Land north of Moat Road, Headcorn Kent

Proposed Site Access and
Associated Highway Works

Road Safety Audit Response Report 2

Report title:	Land north of Moat Road, Heacorn, RSA Response Report 2
Date:	09/10/2023
Document Reference and revision:	20472-09
Prepared by:	DTA Transportation
On behalf of:	Kent County Council

JOB TITLE	Moat Road, Headcorn	CLIENT	Catesby Estates PLC
DRAWING TITLE	Visibility Splays (with Highway Boundary Overlay)		
SCALE	1:500@A3	DRAWN BY	DN
DATE	Nov 2019	DRAWING No	20472-03-3
REVISION	A

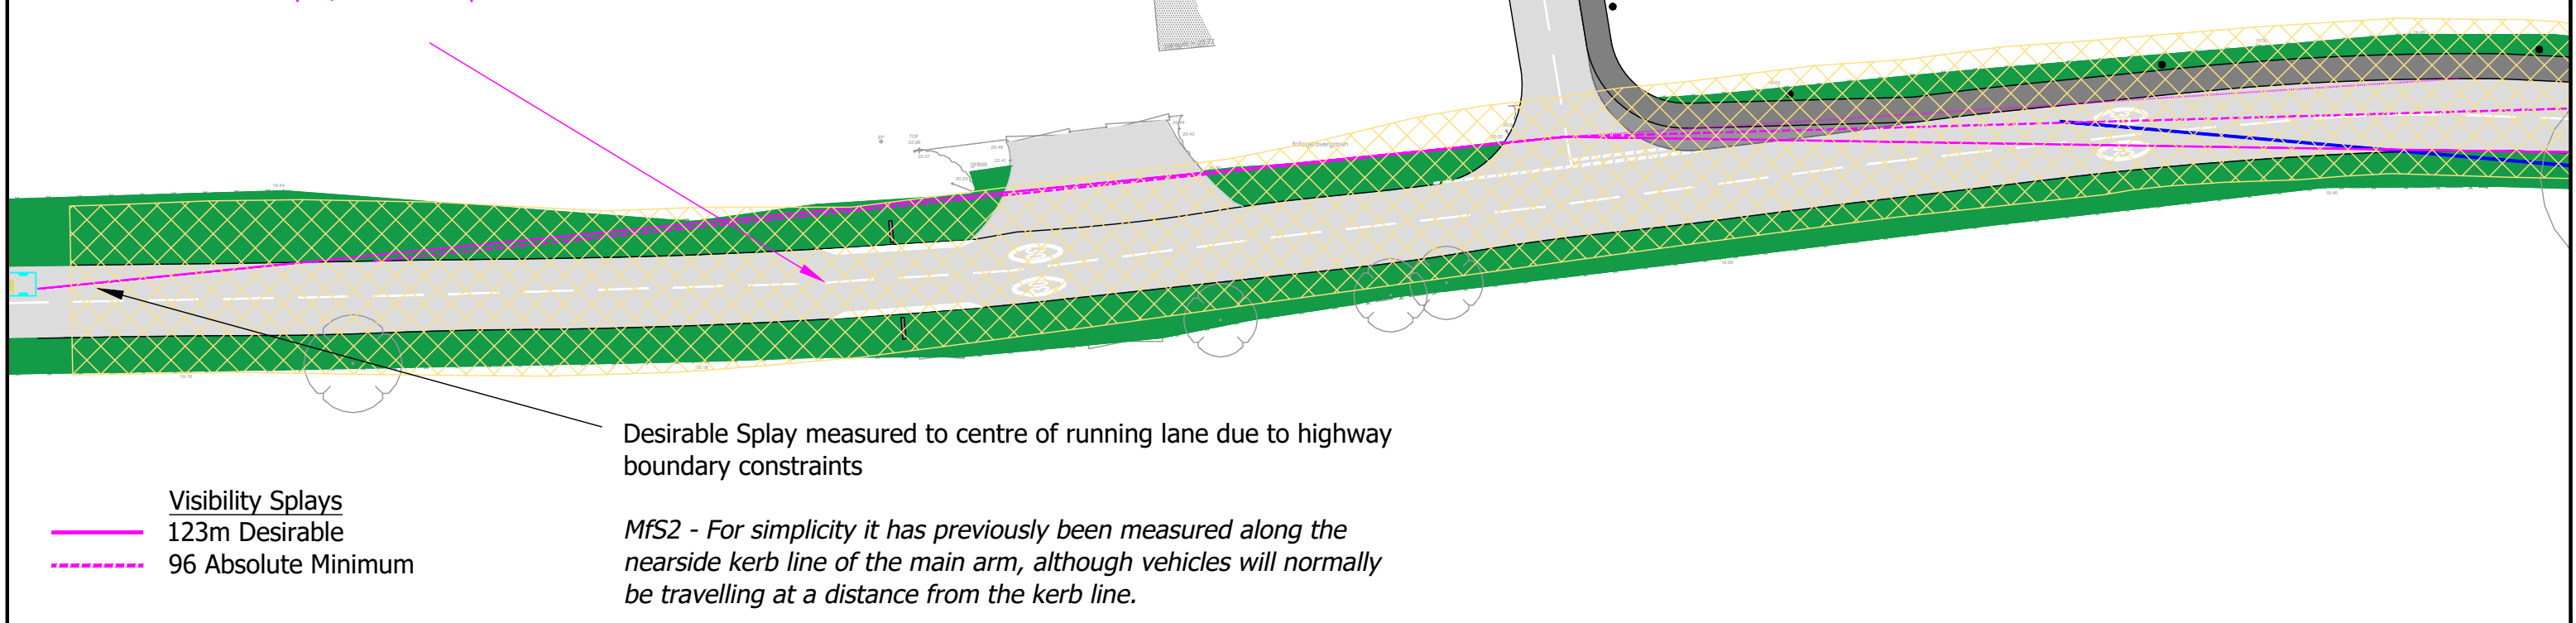
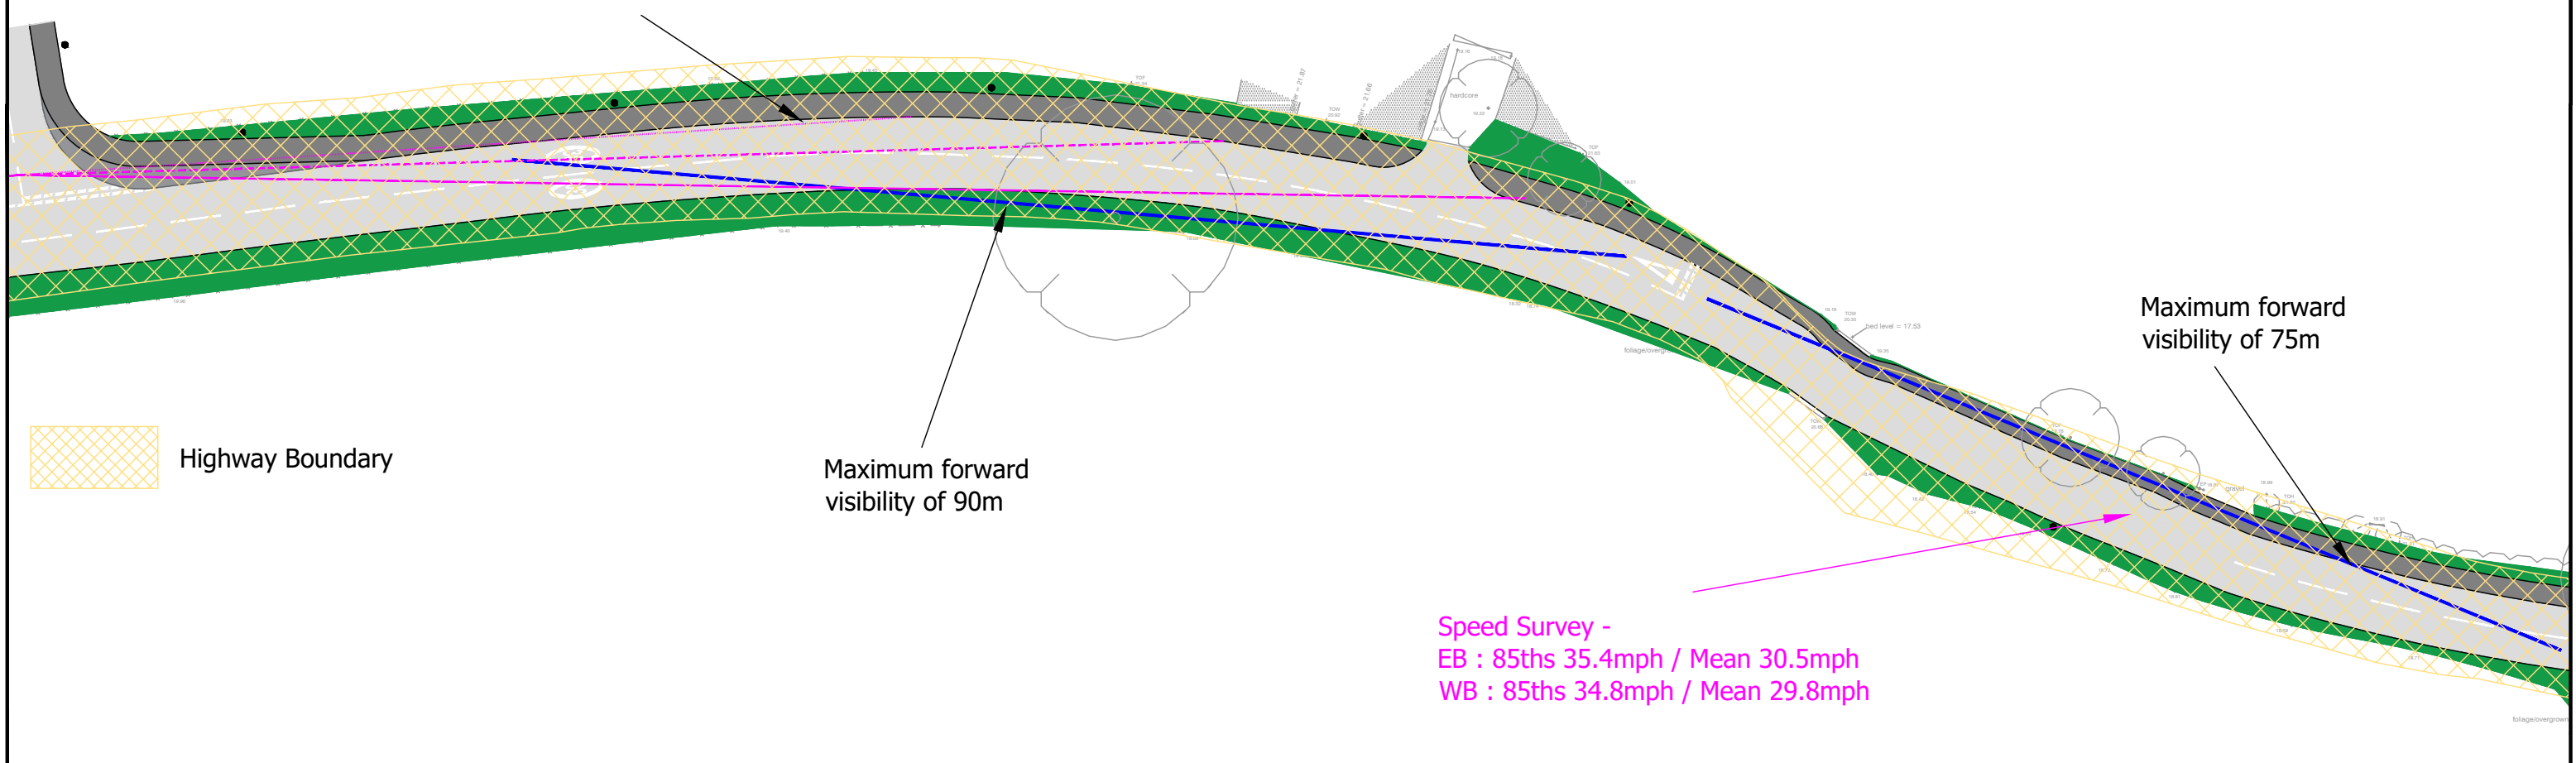
The proposed site access is to be located approximately 20m east of the electrical sub-station. The visibility splay for the junction is shown on drawing 20472-03a-2. It shows a desirable splay of 123m can be accommodated to the centre of the carriageway to west with a 96m absolute minimum splay to the edge of carriageway. Both however, extend through the existing verge which is currently established vegetation.

It is not clear from the proposals what the extent of vegetation clearance will be and therefore the viability of the visibility splays proposed. Should vegetation remain within the visibility splay, this increases the risk of inappropriate turning movements and collisions.

It is recommended that the vegetation within the visibility splay is removed and a maintenance plan provided to ensure the growth of vegetation within the visibility splay is managed.

*The recommendation is accepted. The visibility splays are wholly contained within either land under the control of the developer or public highway. This is shown on **Drawing 20472-03a-3**. Therefore, any vegetation interfering with the visibility splay will be removed. There are no trees that would be affected.*

Key Plan A – Moat Road, Headcorn

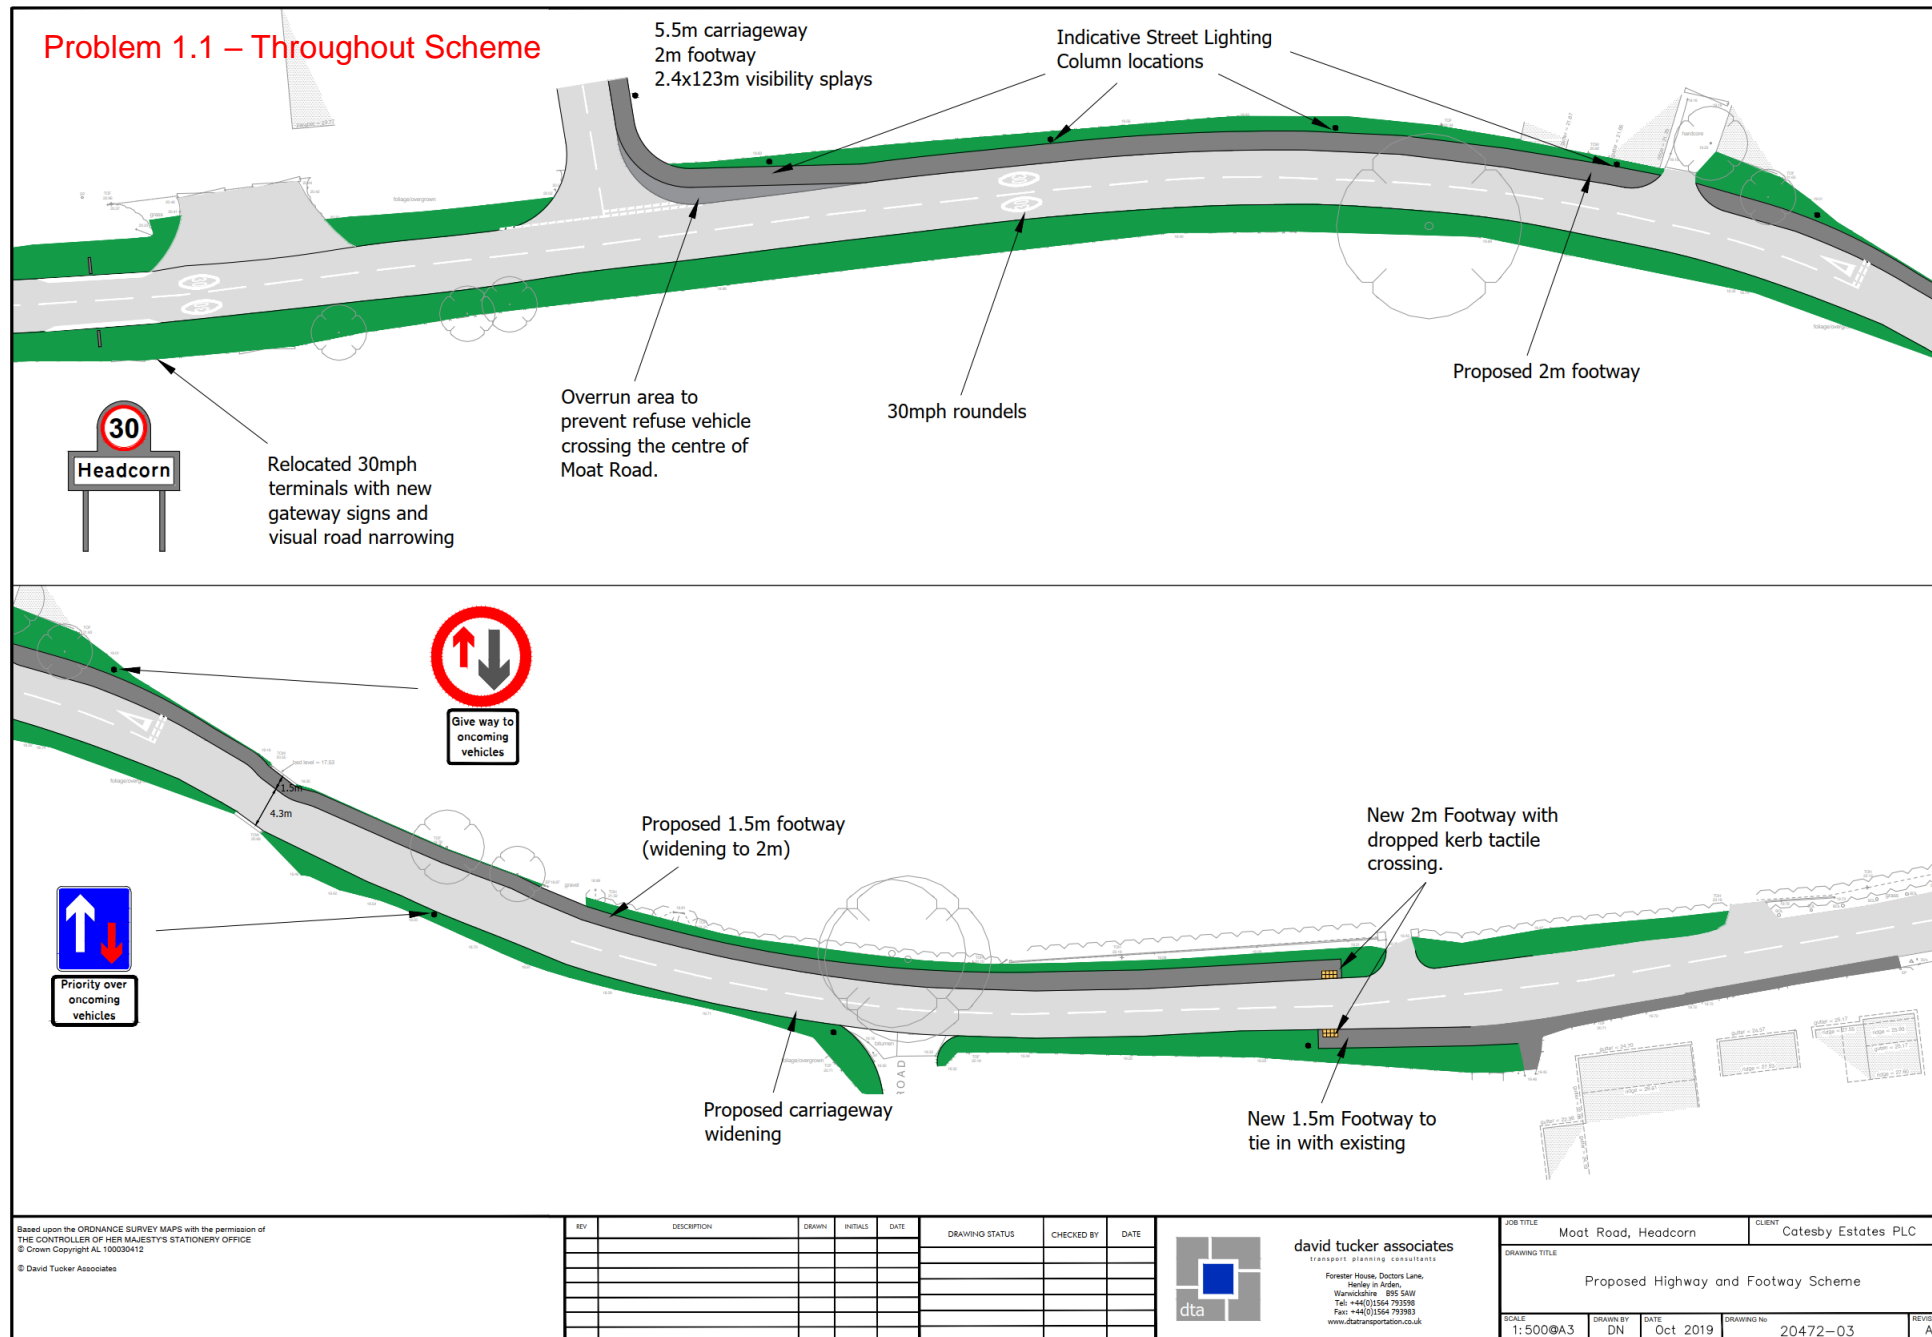
Location: Moat Road – Throughout Scheme.

Summary: Existing street furniture items possibly within footprint of proposed footway.

Within the northern verge of Moat Road are a number of existing street furniture items, including road signs, boundary fencing and telegraph / power poles. Some of these are likely to be relocated / removed as part of the works, such as the relocation of the 30mph gateway. It is not clear, however, if other items, such as the telegraph / power supply pole shown in the background of **Figure 1** will be located within the footprint of the proposed footway.

Should street furniture items be located within the proposed footway, this may reduce the effective width and cause an obstruction to pedestrians, particularly mobility impaired or those with buggies. Where obstructions cause them to walk in the carriageway this increases the risk of them being struck by passing vehicles.

It is recommended that all street furniture items are reviewed and, where located in the proposed footway, are relocated accordingly.

The recommendation is accepted. All existing signs/ street furniture that are affected by the proposed footway will be either be relocated to the verge behind the footway where possible or to alternative locations.

During the detailed design process the need for signs will also be reviewed.

Key Plan B – Moat Road, Headcorn Visibility Splays

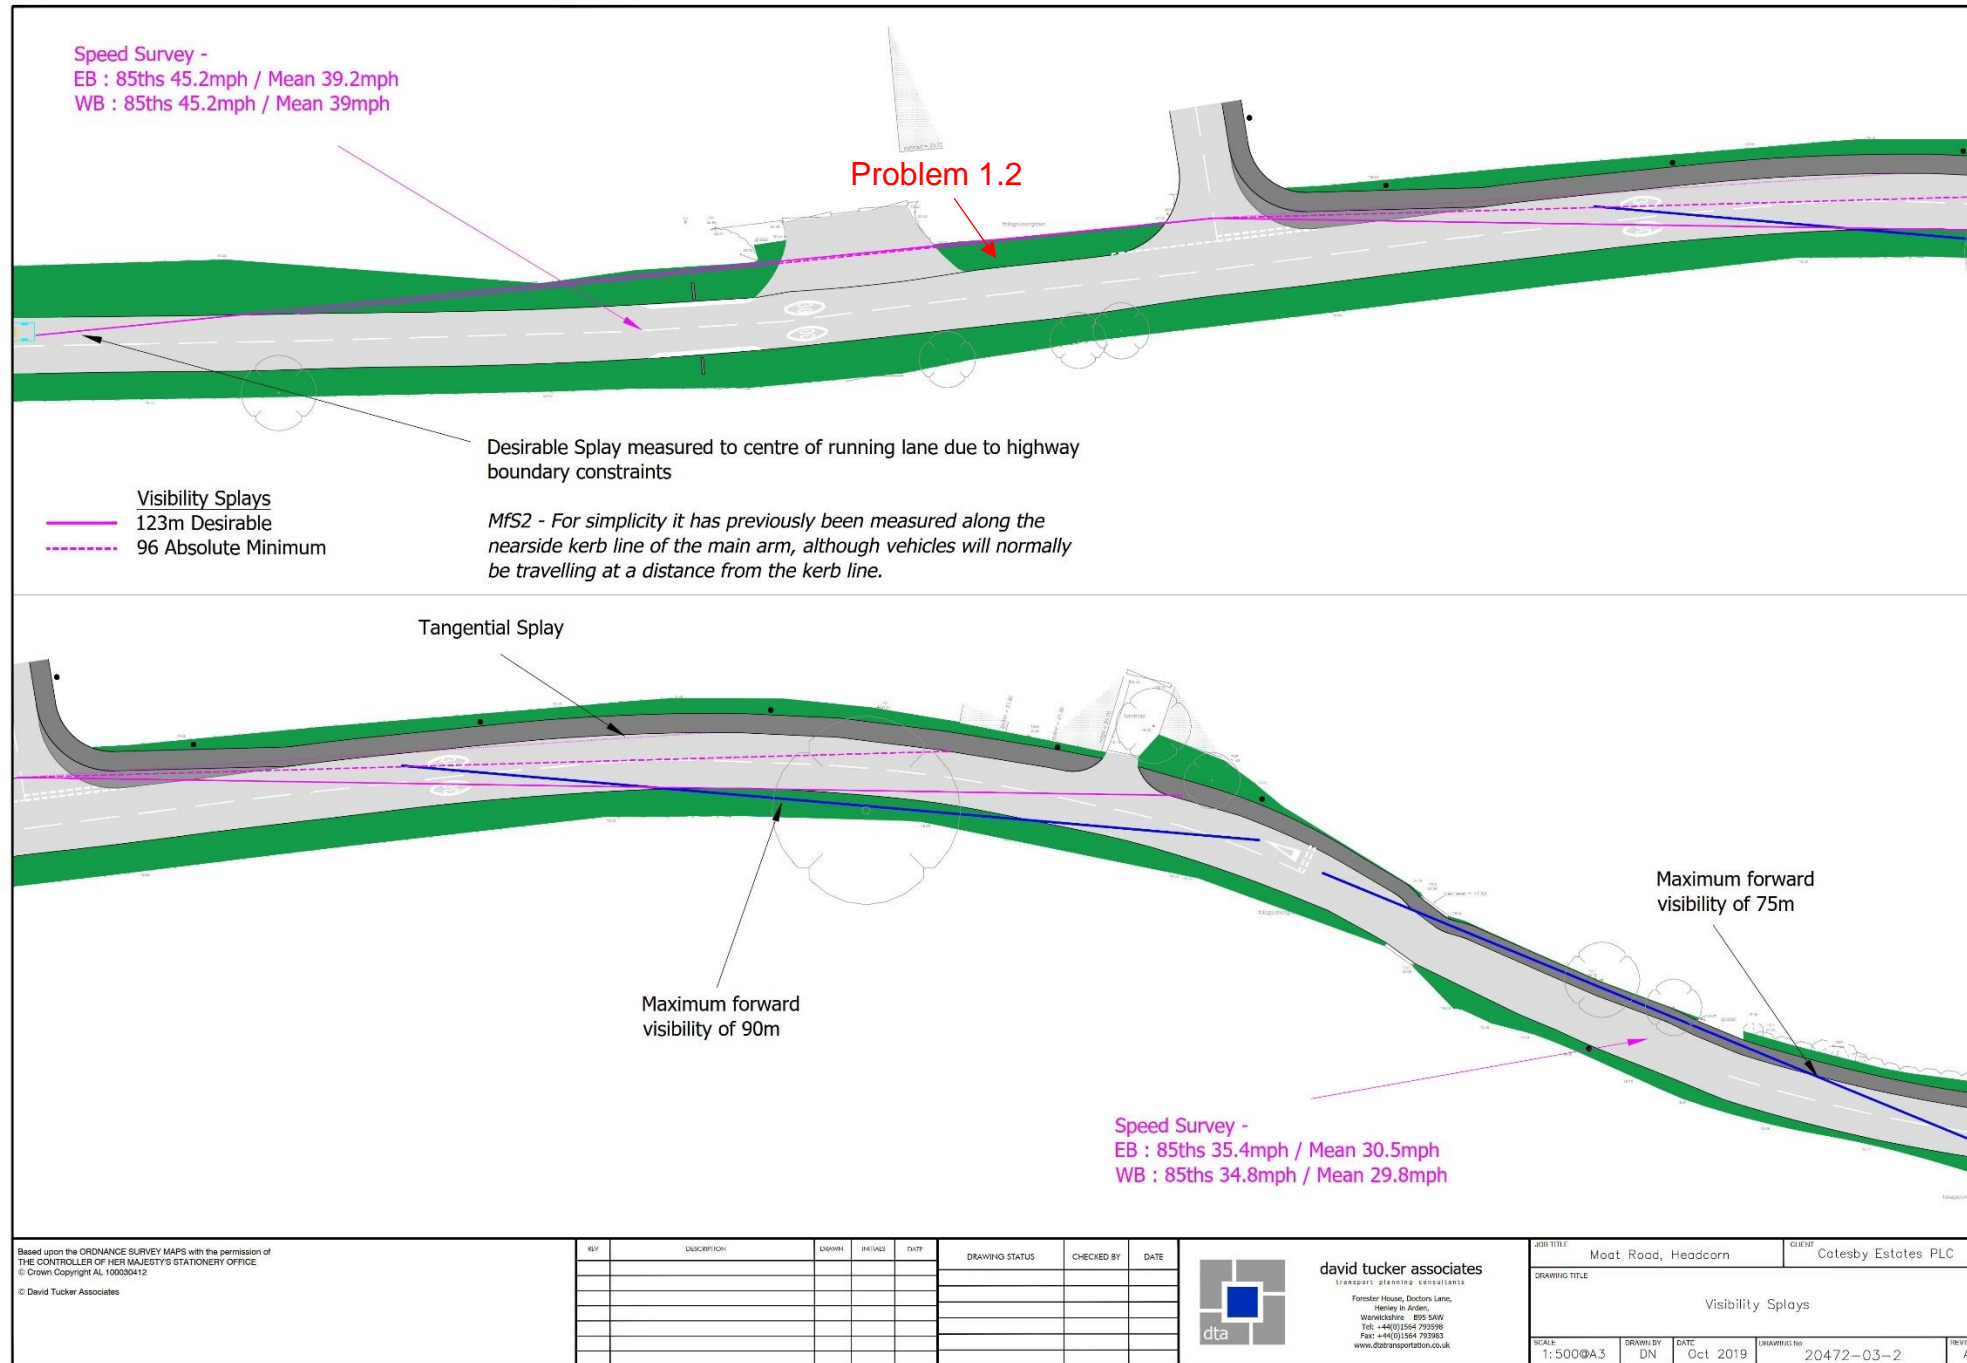
Location: Key Plan B: Proposed site access on Moat Road.

Summary: Vegetation within proposed visibility splays.

The proposed site access is to be located approximately 20m east of the electrical sub-station. The visibility splay for the junction is shown on drawing 20472-03a-2. It shows a desirable splay of 123m can be accommodated to the centre of the carriageway to west with a 96m absolute minimum splay to the edge of carriageway. Both however, extend through the existing verge which is currently established vegetation. **Figure 2** below shows the view to west from the proposed site access.

It is not clear from the proposals what the extent of vegetation clearance will be and therefore the viability of the visibility splays proposed. Should vegetation remain within the visibility splay, this increases the risk of inappropriate turning movements and collisions.

It is recommended that the vegetation within the visibility splay is removed and a maintenance plan provided to ensure the growth of vegetation within the visibility splay is managed.
